## Planning Commission Staff Report

<b>Project Type:</b>	Site Development Section Plan
<b>Meeting Date:</b>	July 11, 2016
<b>From:</b>	Justin Wyse Senior Planner
<b>Location:</b>	North of North Outer 40 Road, west of its intersection with Boone's Crossing.
<b>Applicant:</b>	Stock and Associates
<b>Description:</b>	<b><u>MPD Investments, Adjusted Lot 2 (Beyond Self Storage at Chesterfield)</u></b> <b><u>SDSP:</u></b> A Site Development Section Plan, Landscape Plan, Lighting Plan, Architectural Elevations, Architect's Statement of Design, and Parking Modification for a 2.99 acre tract of land zoned "PI" Planned Industrial District located north of North Outer 40 Road, west of its intersection with Boone's Crossing.

Stock and Associates, on behalf of NorthPoint Development, has submitted a request for a 108,900 square foot self-storage facility located on the north side of North Outer 40 Road, west of its intersection with Boone's Crossing. The subject site is zoned "PI" Planned Industrial District and is governed under the terms and conditions of the City of Chesterfield Ordinance Number 2411.

Sheet Title: Landscape Plan  
Sheet No: L-1  
Date: 4/29/16  
Job #: 613.048

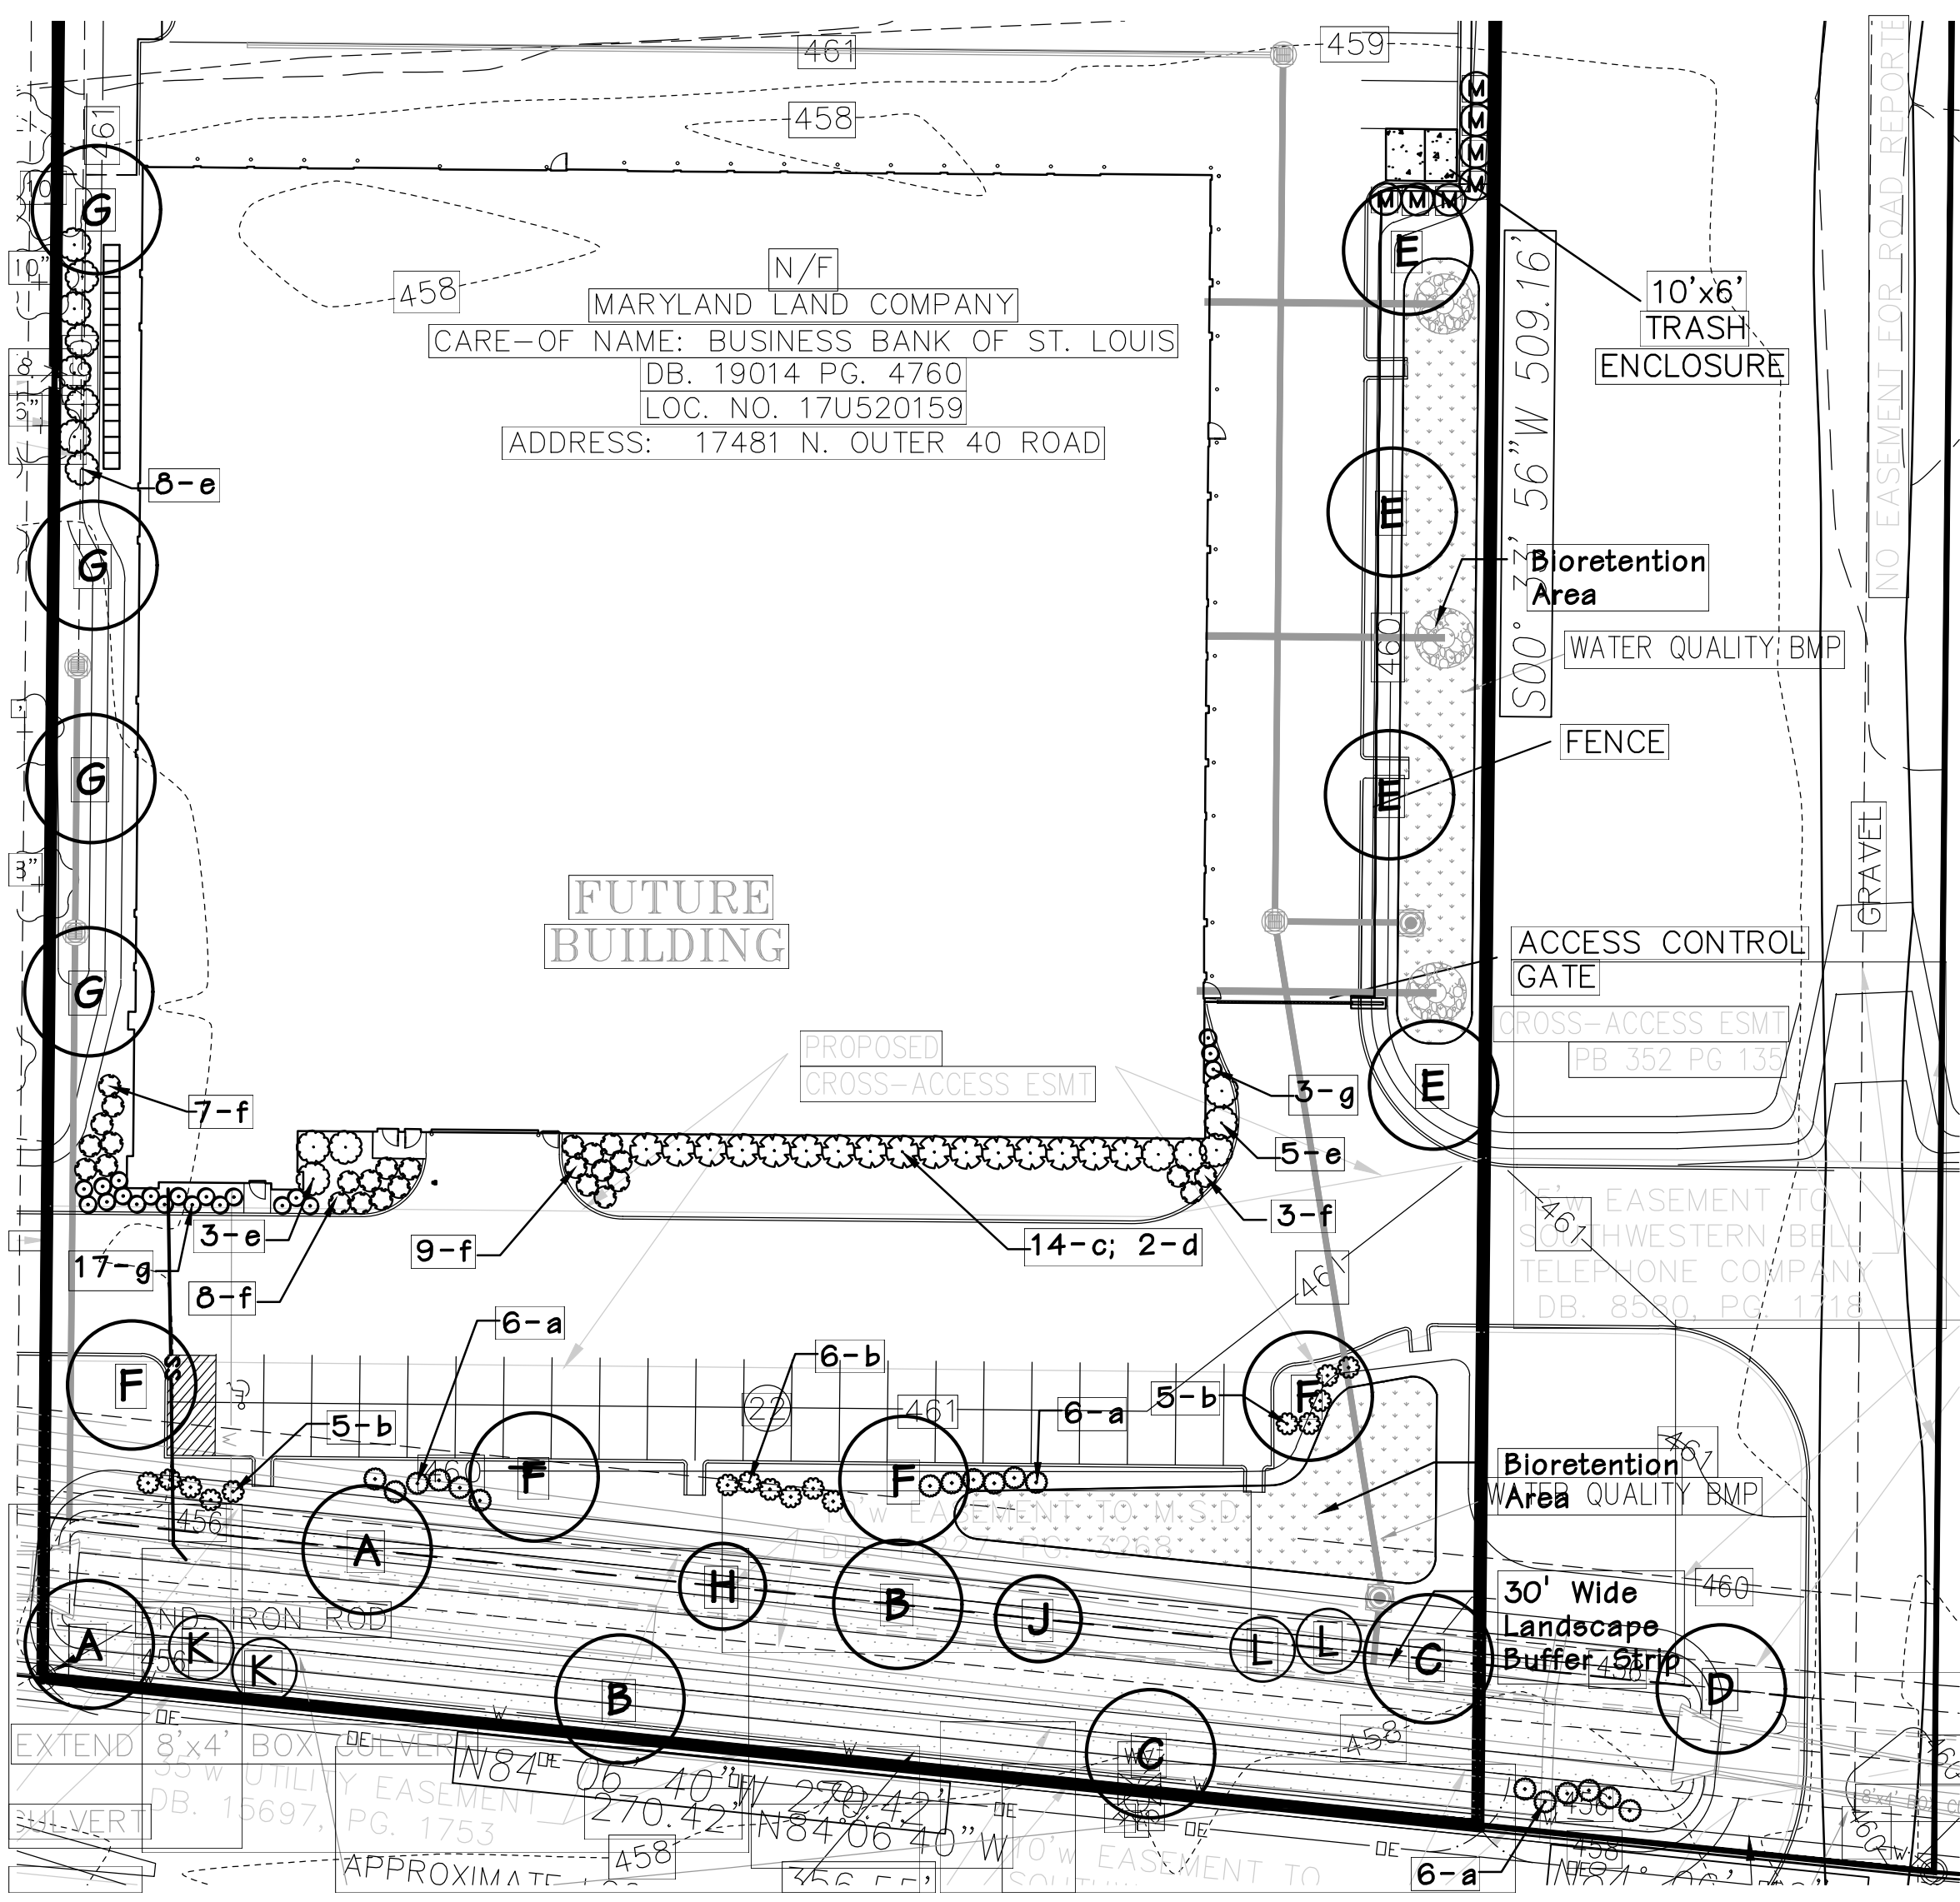
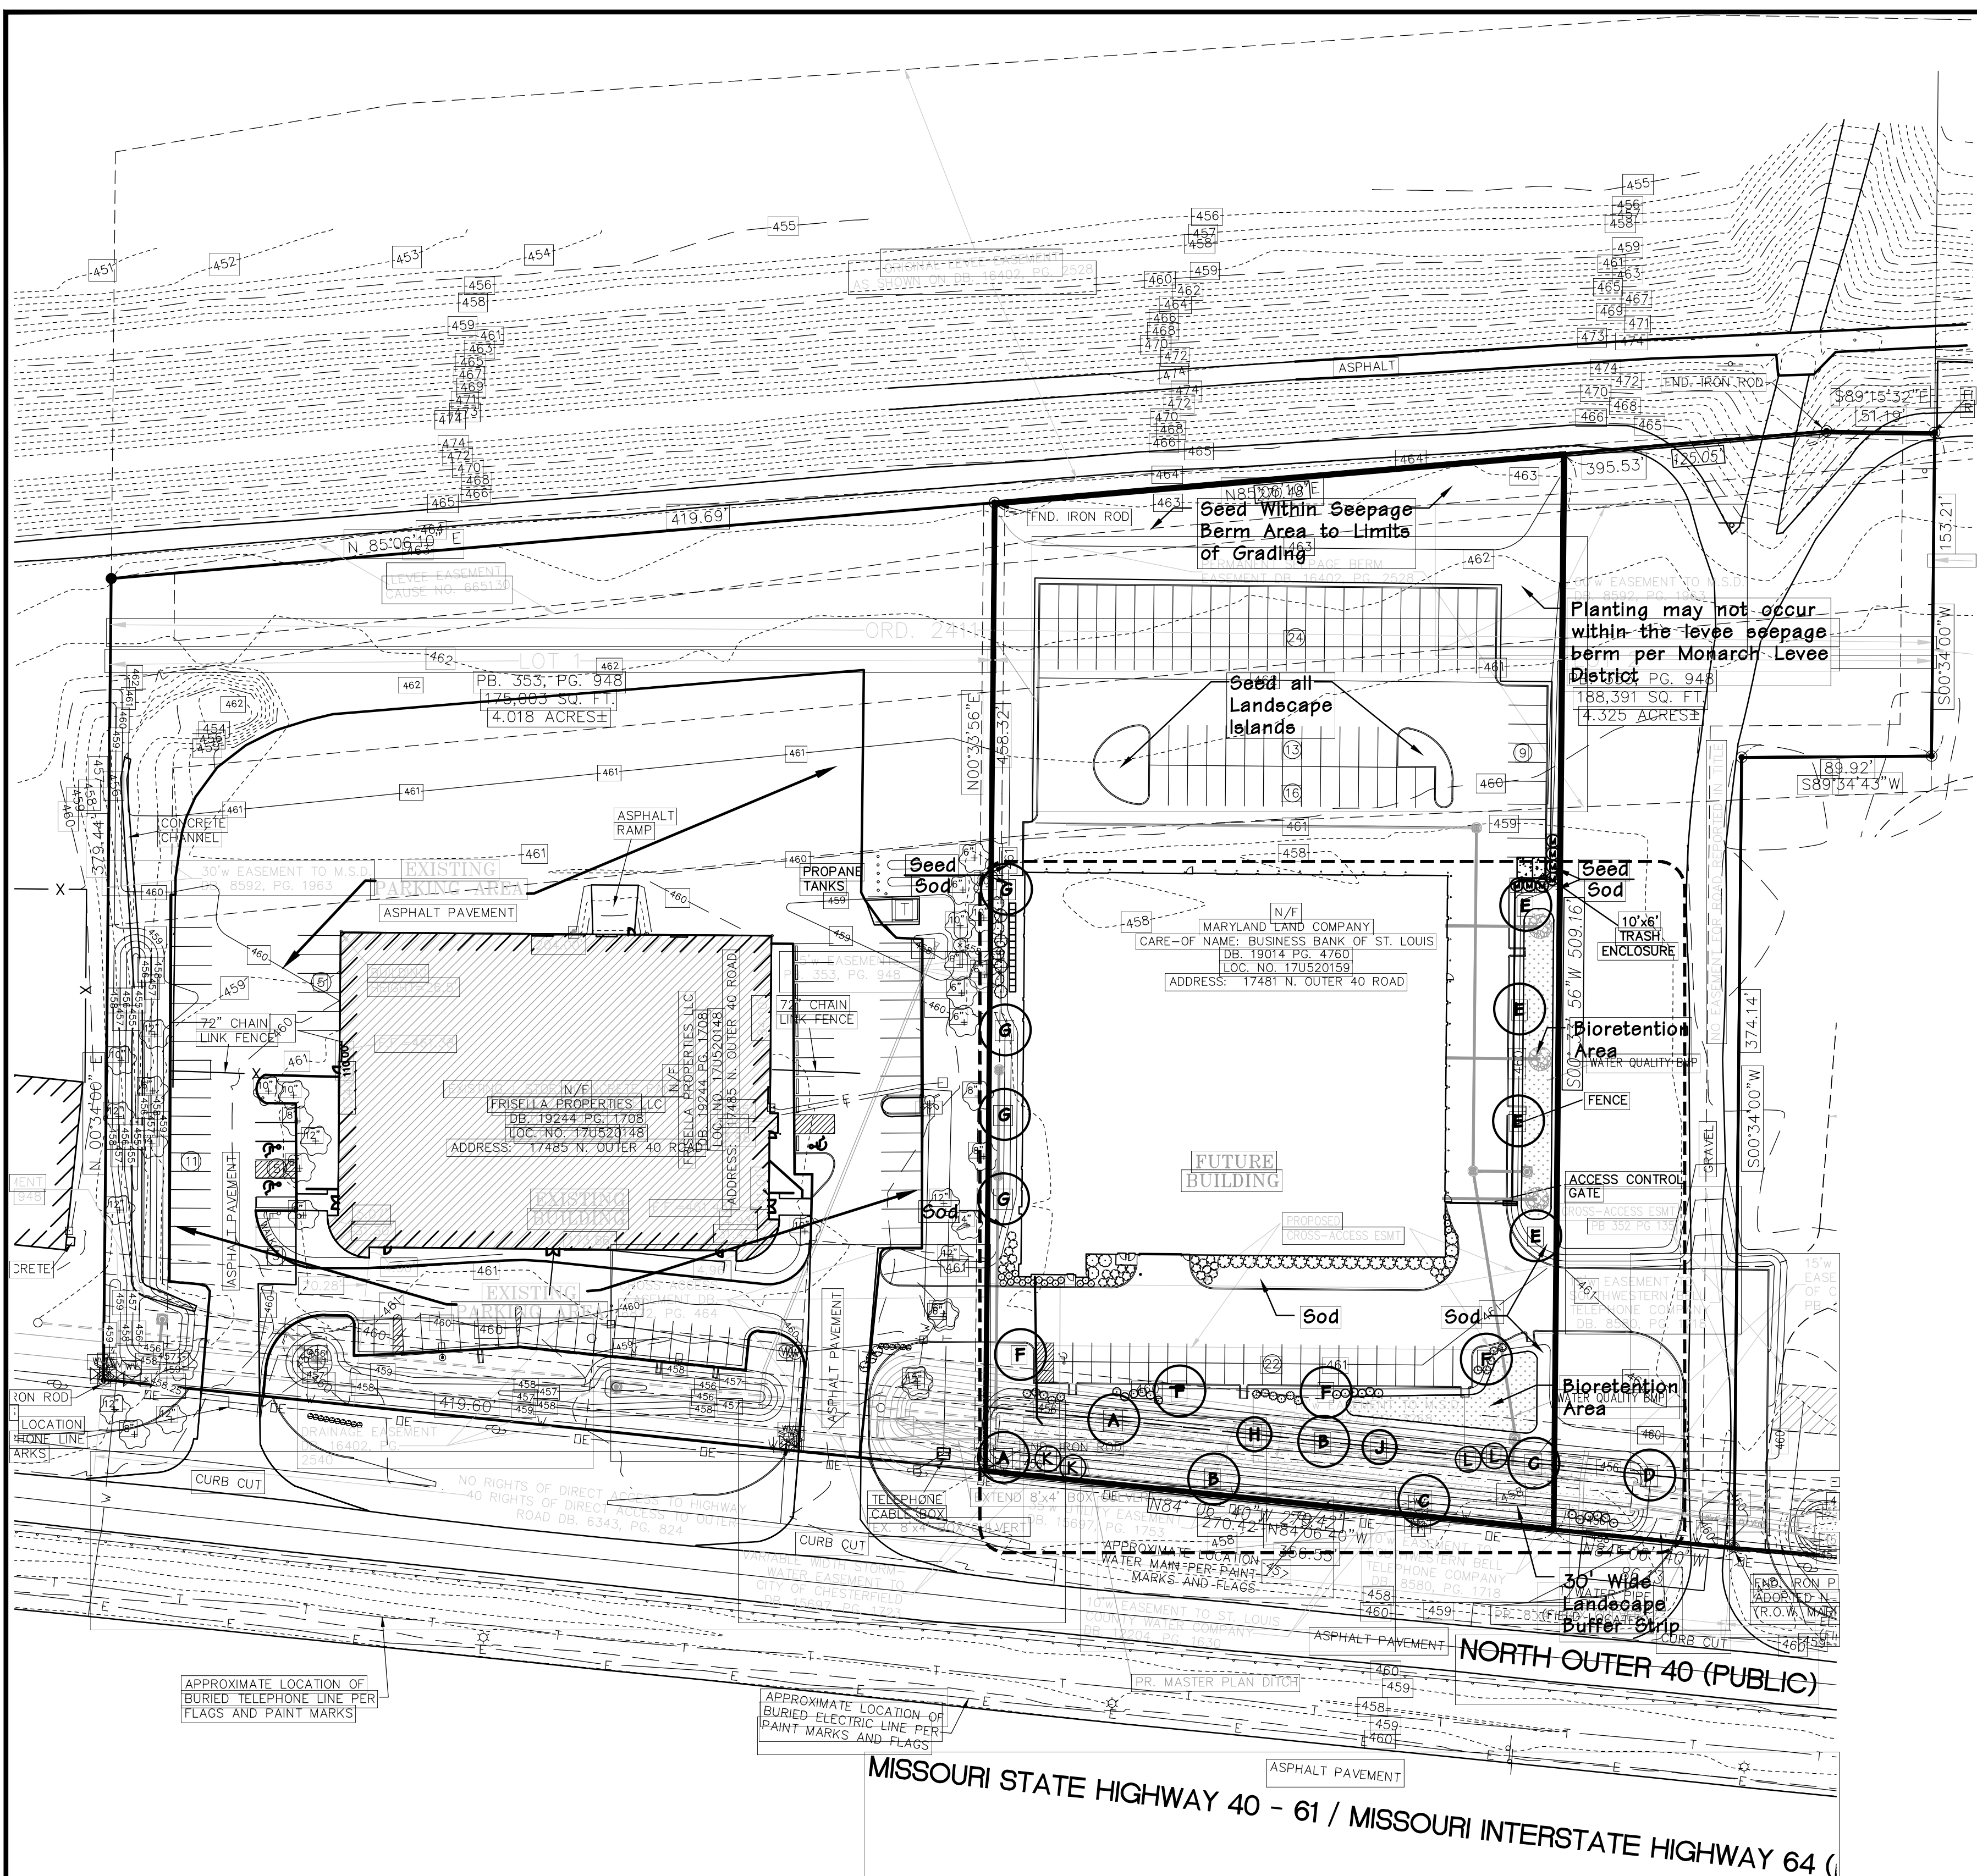
*3. Relocate the front row of shrubbery near the front parking area as far north as possible in proximity with the parking lot with consideration of the bio-retention area being the constraining factor.*

The Landscape Plan has been updated to address this request. Plantings that were proposed along the northern and southern portions of the Master Stormwater Channel have been relocated along the southern edge of the parking lot. The new location will assist in shielding glare from vehicle headlights while vehicles enter and exit the parking area.

**2 WEST ELEVATION**  
1/8" = 1'-0"

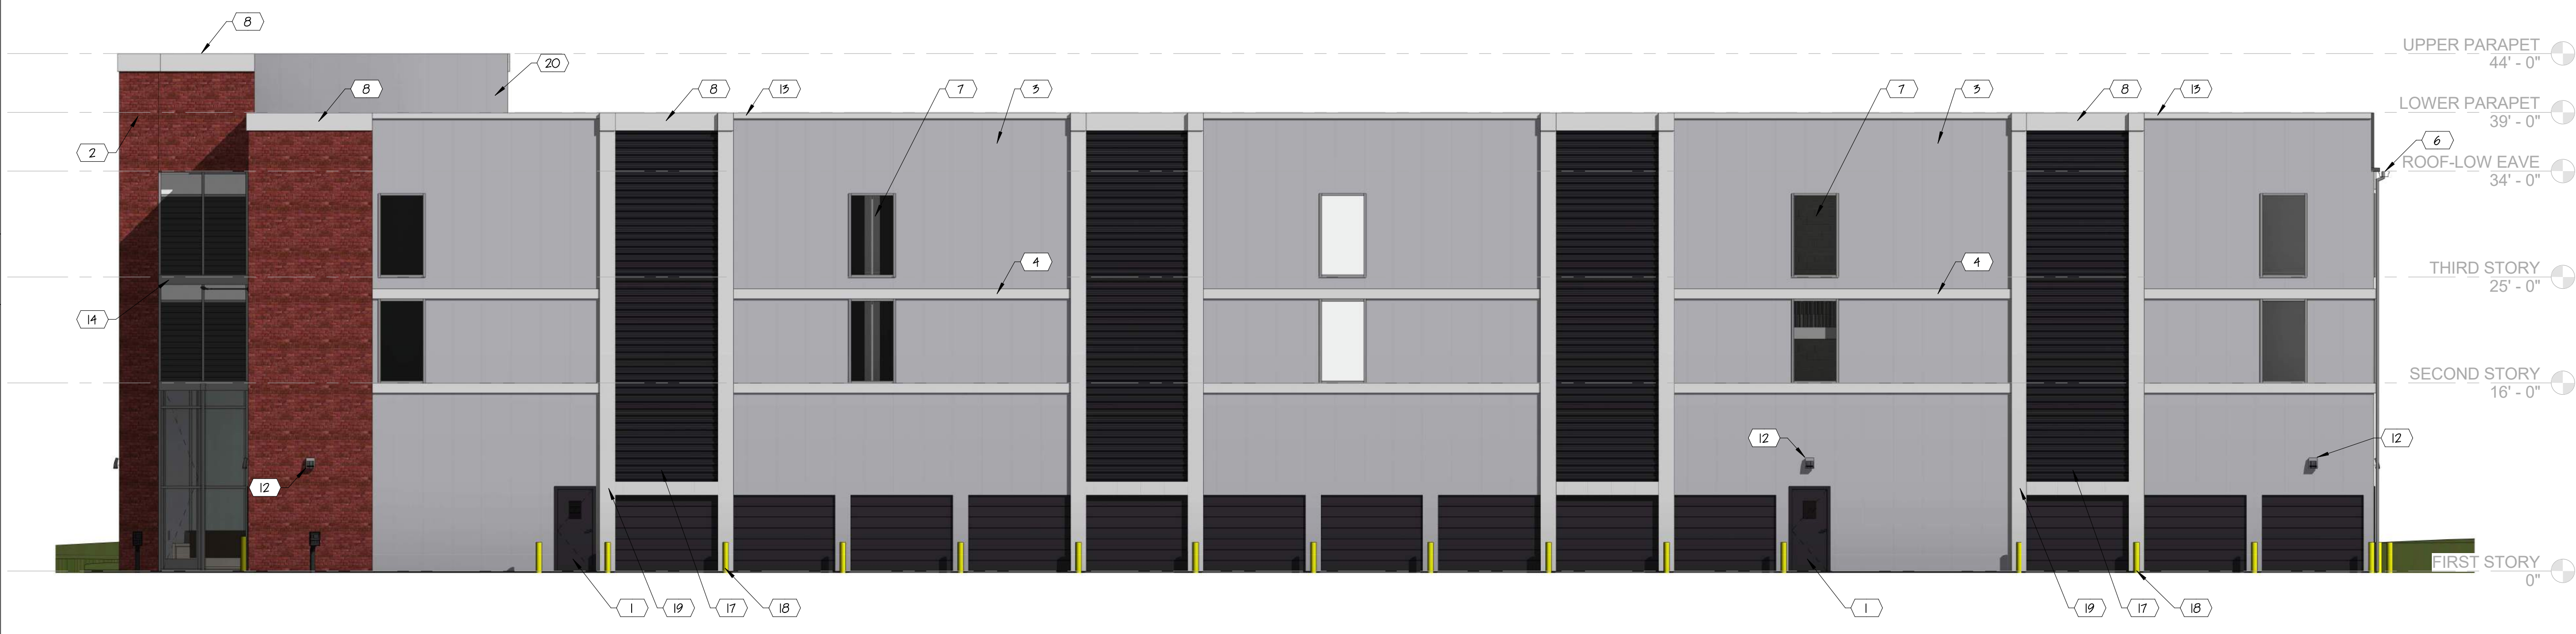
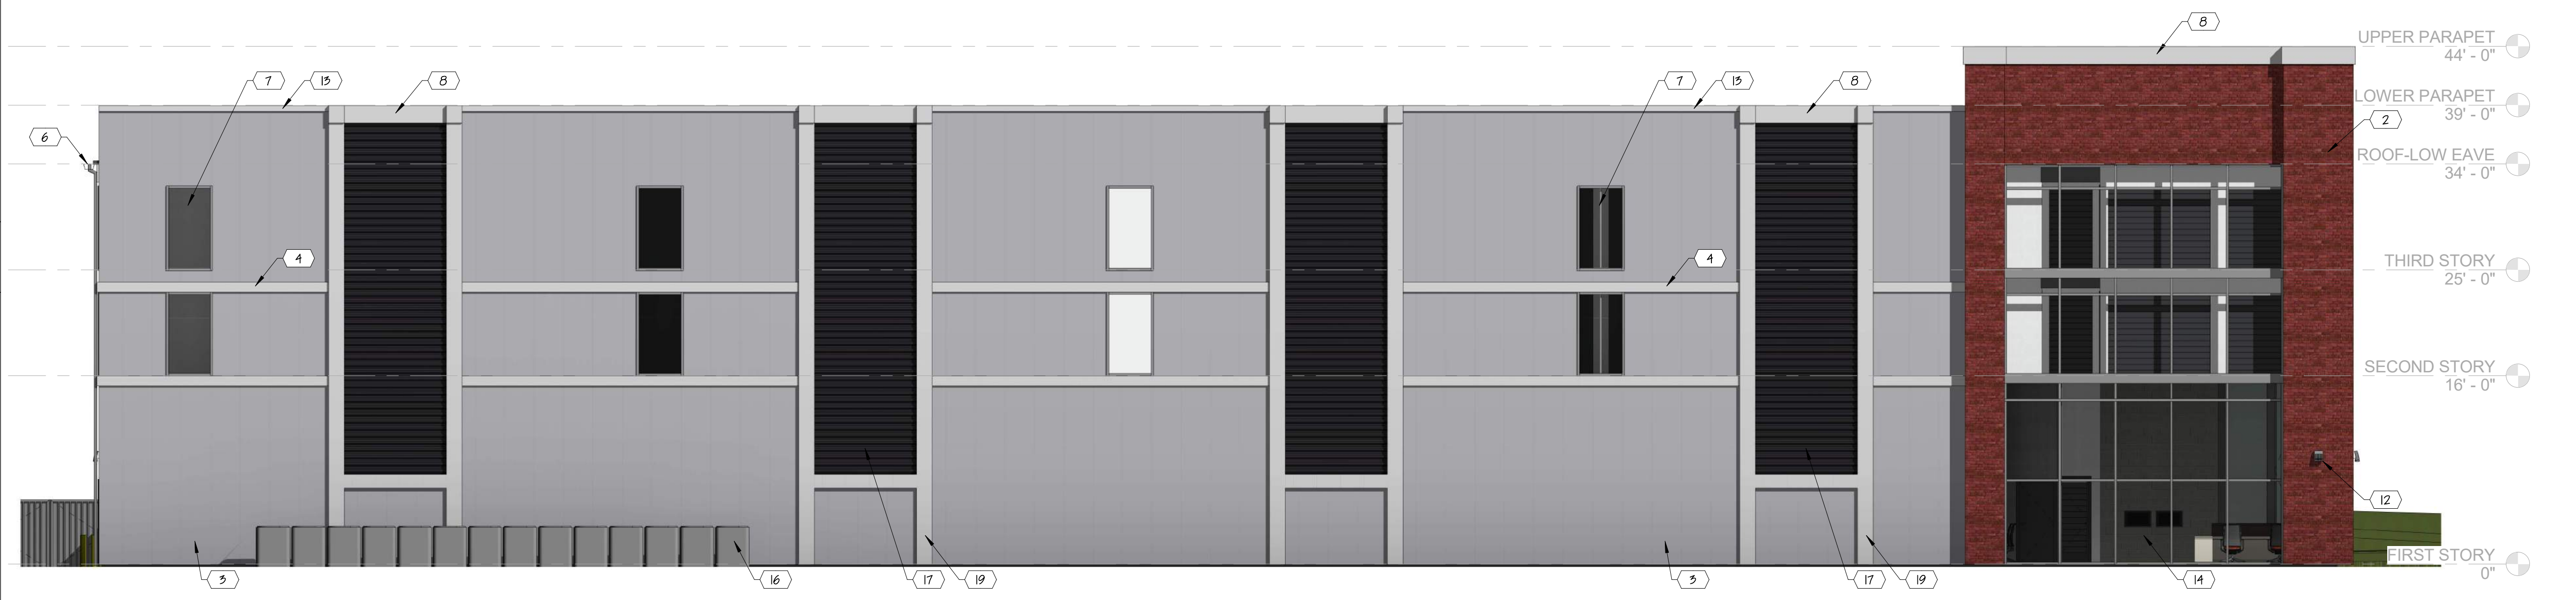
1. *Increase the brick height to the southern elevation in line with the proposed man doors.*

*2. Extend the landscaping near the office of the southern portion of the west elevation.*

In response to this recommendation, the applicant extended the brick wainscoting to the top of the entry doors along the southern elevation as recommended by ARB.

The applicant has added additional shrubs along the requested portion of the structure. The proposal adds 7 Minuet Weigela and 17 Prairie Fire Switch Grasses. These plantings are also used on the southern portion of the east elevation to maintain a consistent mix of plantings along the frontage of the structure.
